Considerations on the Ranging Channels (AWD-15.3.9.1.4/15.3.9.2.4)

IEEE C802.16m-09/1501r1

Re: IEEE 80216m-09/0028r1, "Call for Comments and Contributions on Project 802.16m Amendment Content"
AWD-15.3.9.1.4/15.3.9.2.4

Purpose: To be discussed and adopted by TGm for the IEEE 802.16m AWD.

Figure 500—Ranging channel structures in the time domain

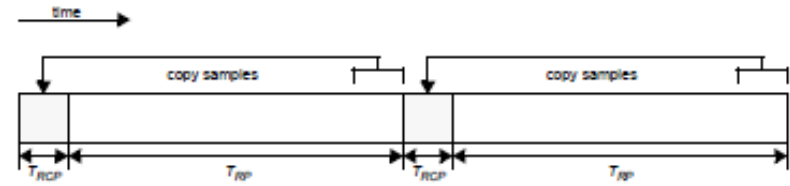
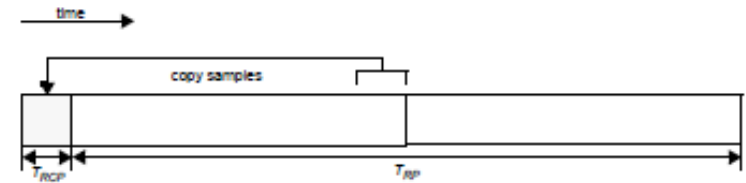
- 4 structures with 5 formats
- Need to check the performance of Format 4 and its usage
 - ✓ Can use freq. domain detector?
 - ✓ High-complexity & phase discontinuity?

👉 Remove the Structure 4 & Format 4
